STATE OF HAWAII
DEPARTMENT OF TRANSPORTATION
HIGHWAYS DIVISION

DEMOLITION & GRADING PLAN

OAHU DISTRICT WAREHOUSE BUILDING

Project No. HWY-0-05-98

1 CONC WALL
SCALE: 1"=1'-0"

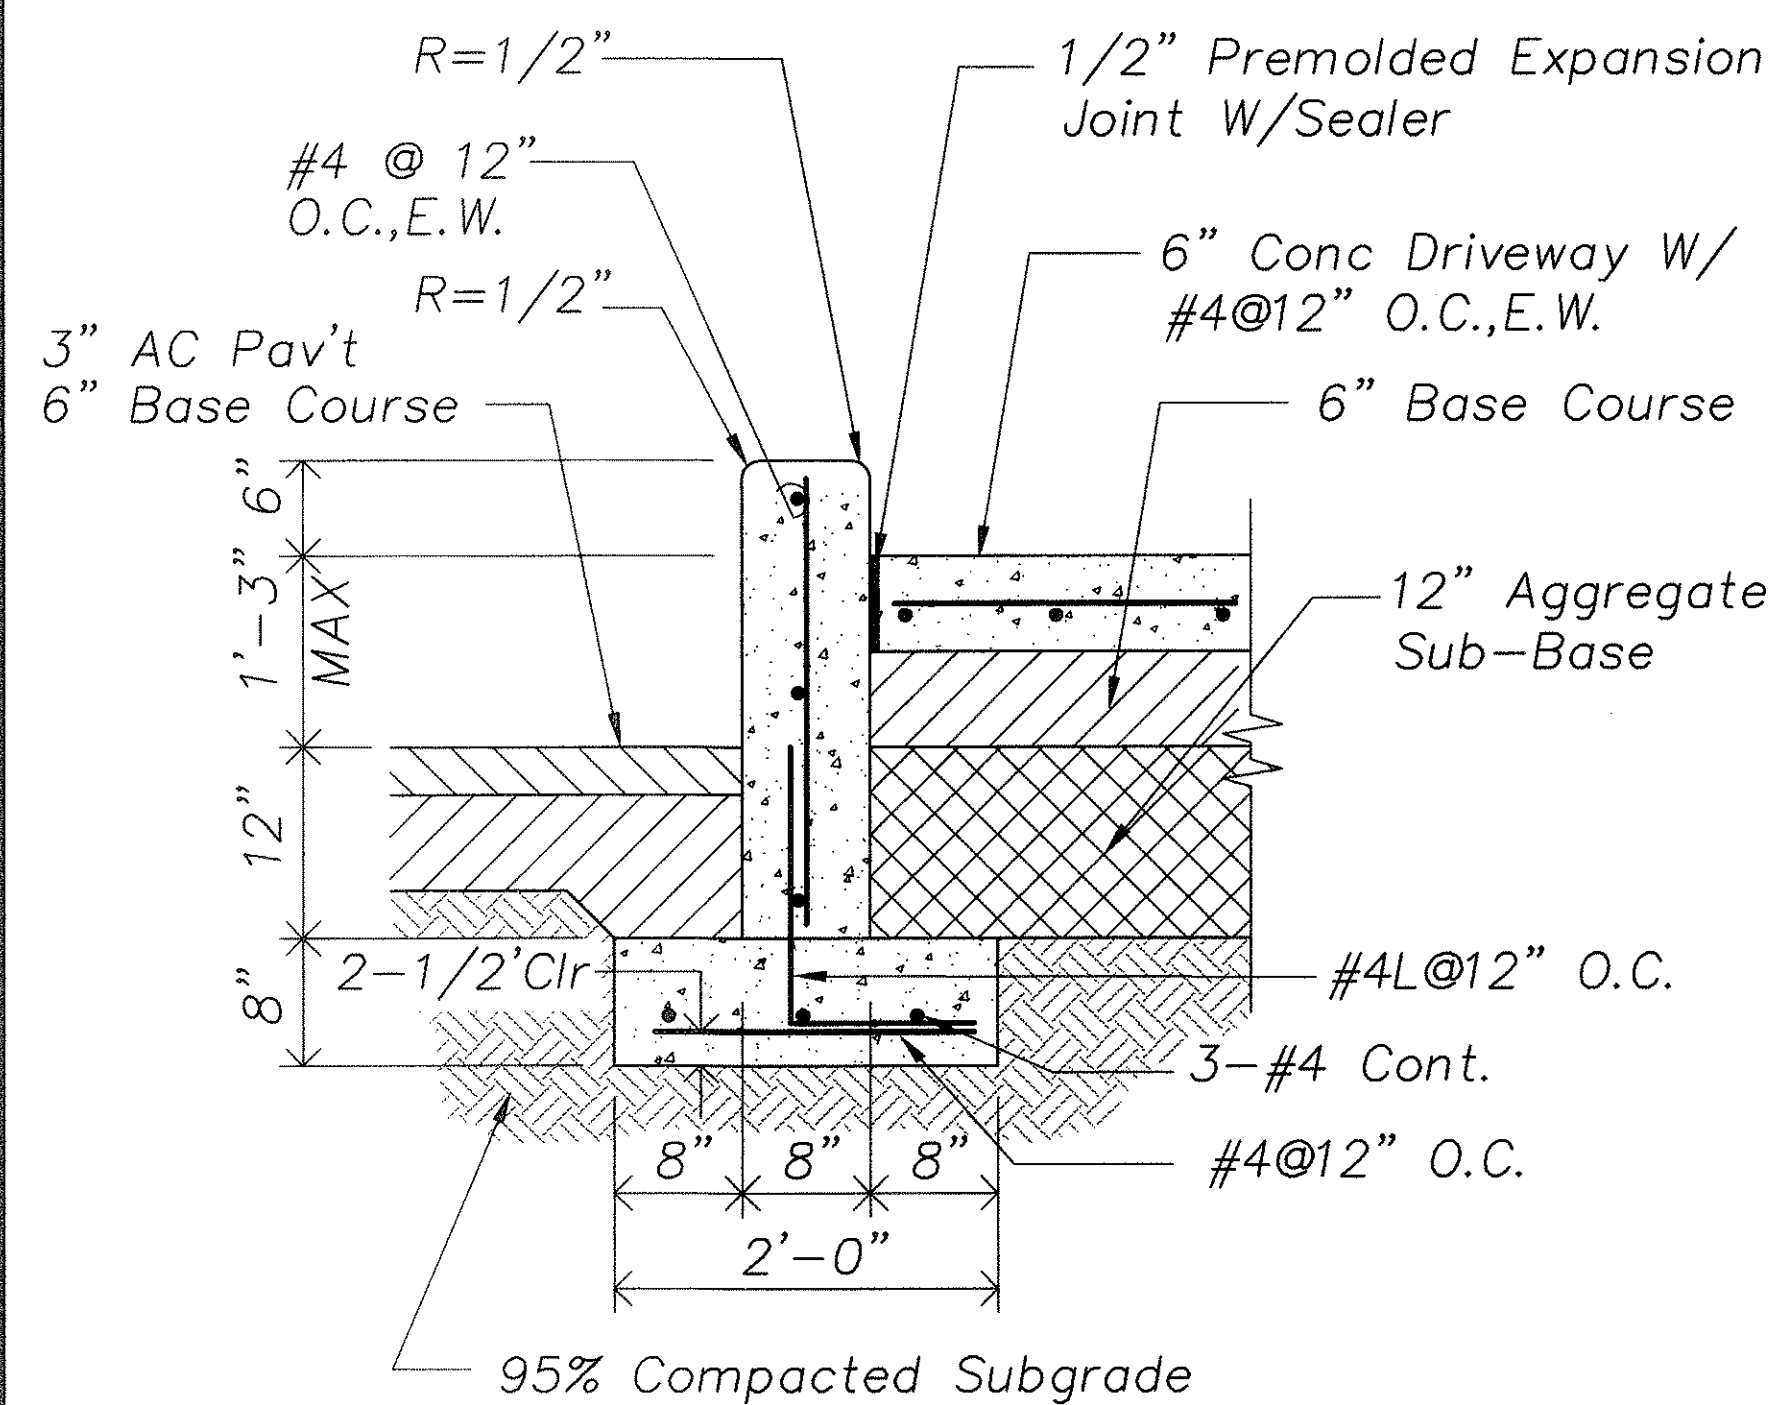
C-6	Rev. Conc Wall, Conc Thrust Gutter, Conc Jacket & Drain Inlet Details
June 2000	
Date	Revision
STATE OF HAWAII DEPARTMENT OF TRANSPORTATION HIGHWAYS DIVISION	
DETAILS	
OAHU DISTRICT WAREHOUSE BUILDING	
Project No. HWY-0-05-98	
Scale: AS SHOWN	Date: APRIL 2000
SHEET No. C6 OF 116 SHEETS

1
C-7 CHAINLINK FENCE W/BARBED WIRE
NO SCALE

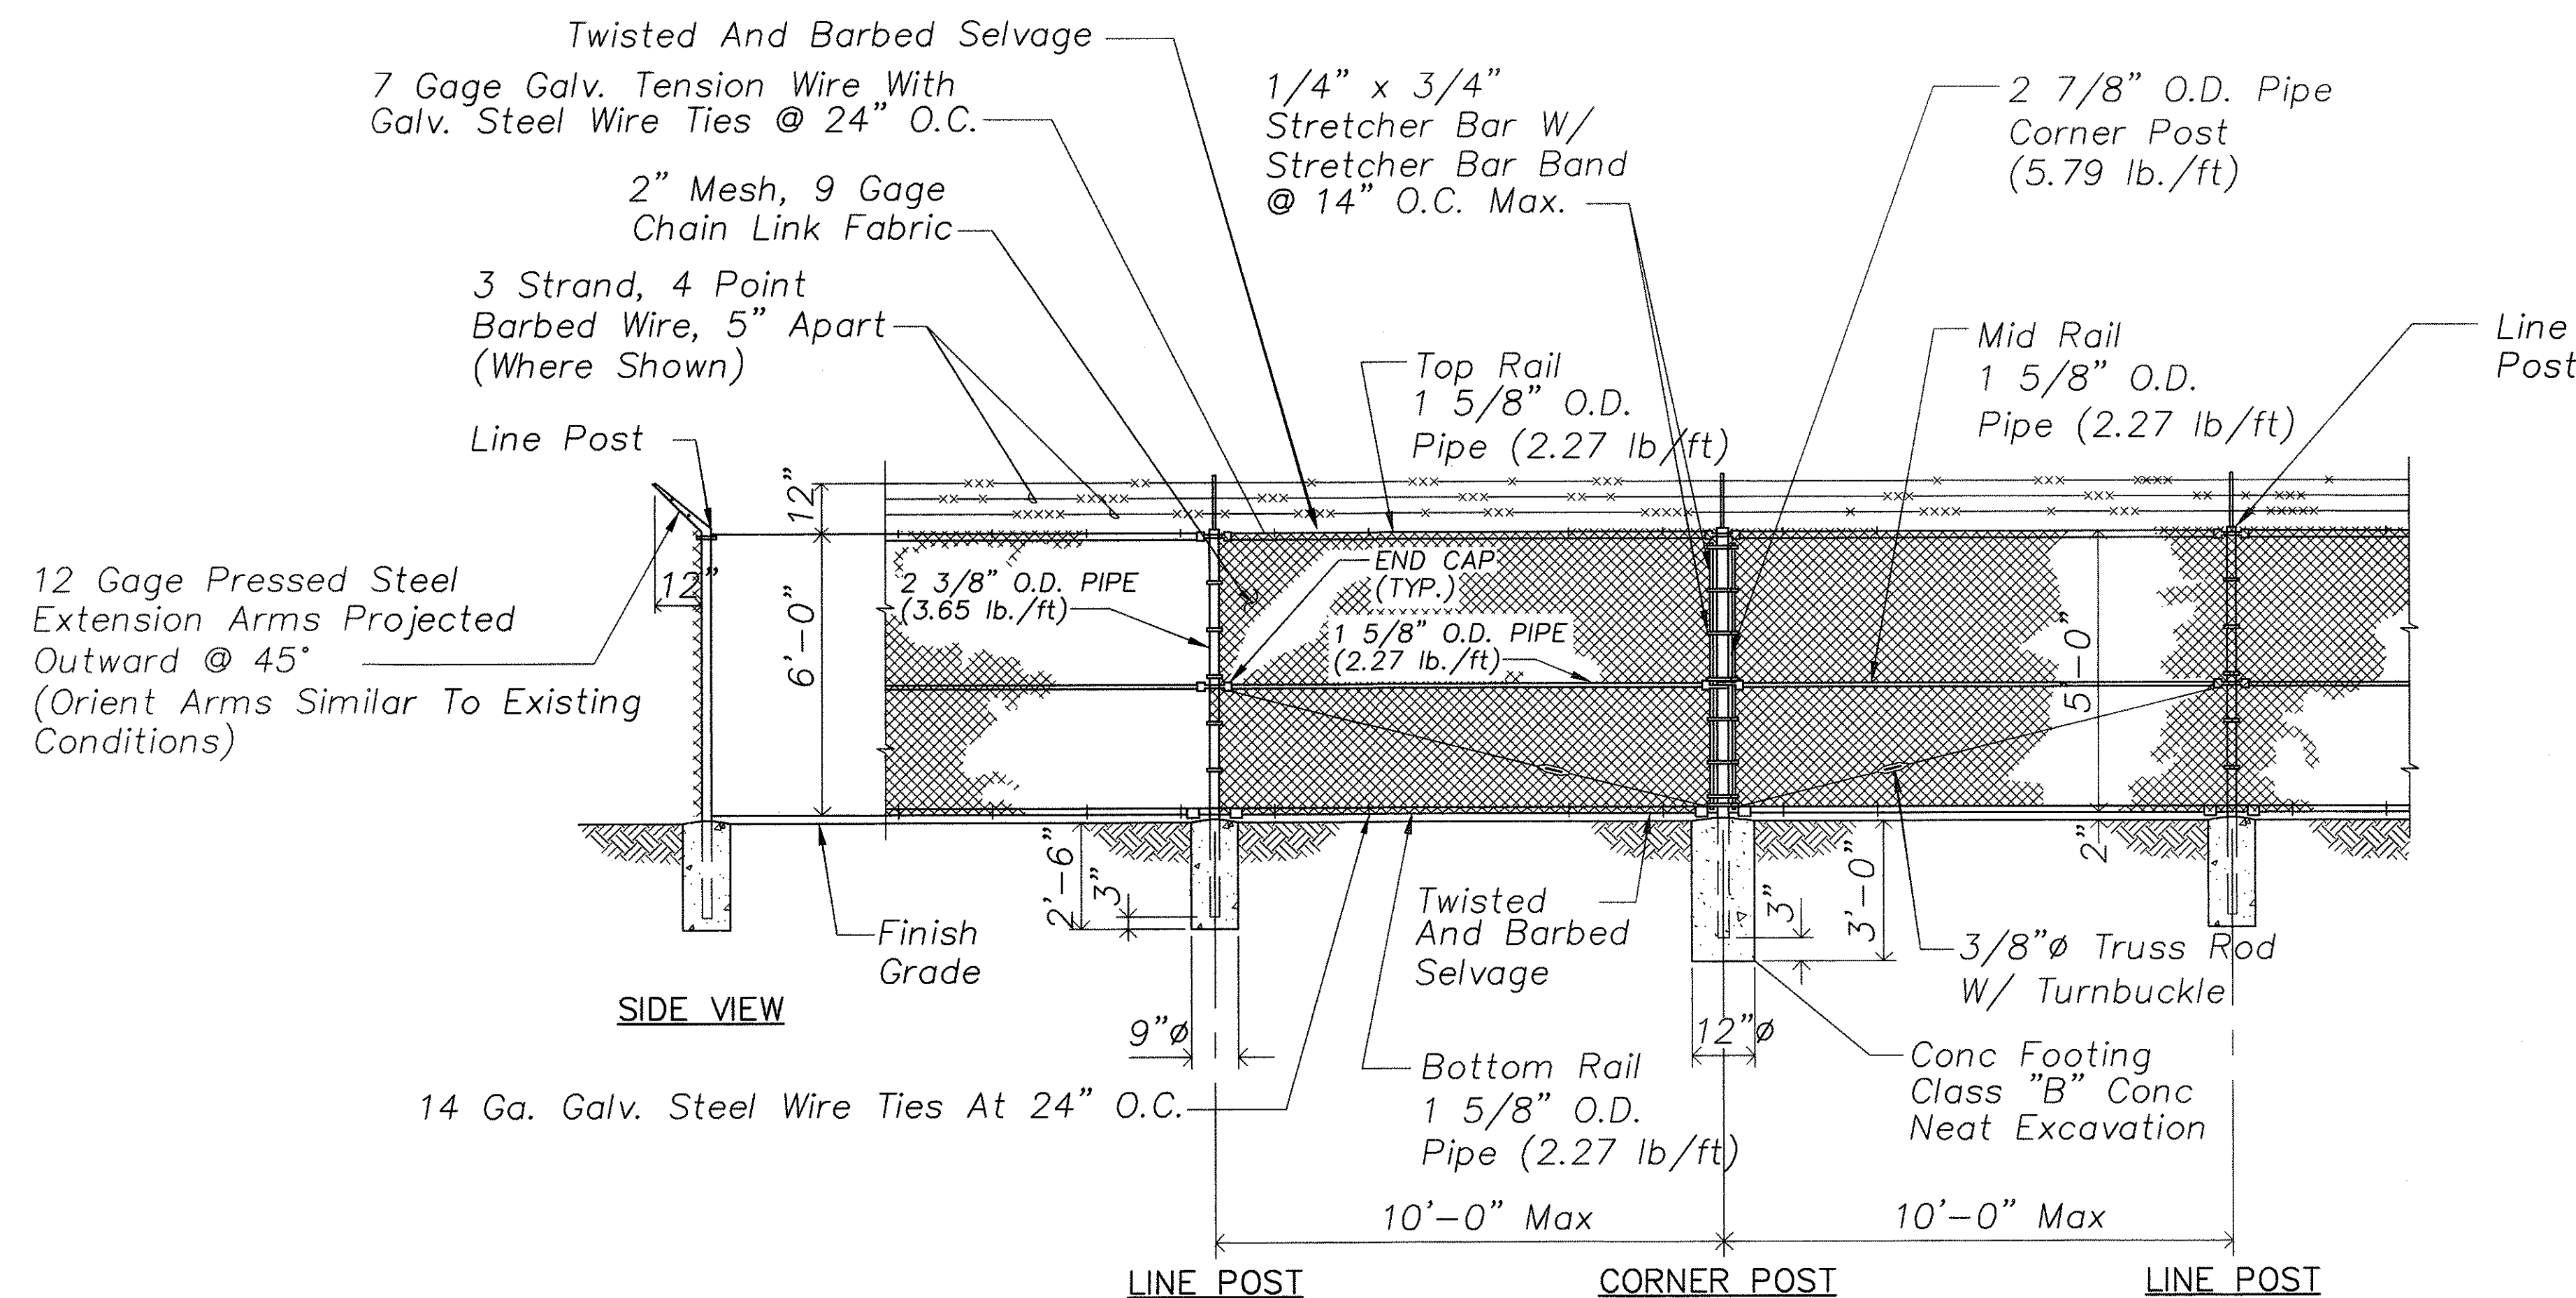
C-7	Rev. Added sheet, w/Barbed Wire Detail
June 2000	
Date	Revision
STATE OF HAWAII DEPARTMENT OF TRANSPORTATION HIGHWAYS DIVISION	
DETAILS	
OAHU DISTRICT WAREHOUSE BUILDING	
Project No. HWY-0-05-98	
Scale: AS SHOWN	Date: APRIL 2000
SHEET No. C7 OF 116 SHEETS
